Ballinacurra Mill LRD at Ballynacorra,
Midleton, Co. Cork

Stage 1 Road Safety Audit

February 2025

2.1. Problem: Perpendicular parking in proximity to raised pedestrian crossing.

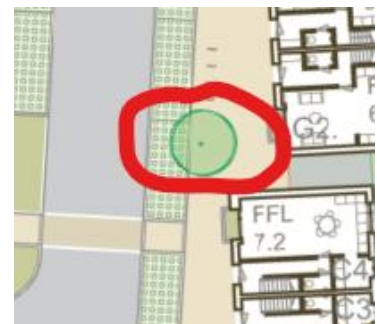
The following image shows the location of perpendicular parking associated with a private detached dwelling that may result in a reversing car encroaching onto the proposed raised pedestrian table at the main access to the site. There is a potential that this could result in an accident with pedestrians using this crossing.

If possible the crossing should be moved towards the main road and away from this parking to avoid this potential safety issue. Alternatively the parking serving this dwelling could be revised.

To be completed by the Designer			To be Completed by Audit Team Leader
Paragraph No. in Safety Audit Report	Problem accepted (yes/no)	Recommended measure accepted (yes/no)	Comments	Alternative measures or reasons accepted by auditors (yes/no)
2.1	Y	Y	Crossing may be moved to align with footpath	
2.2	Y	Y	Tree and Bicycle Parking Moved	
2.3	Y	Y	Signage and Tactile Paving Addition	
2.4	Y	Y	Outside of Scope of Drawings
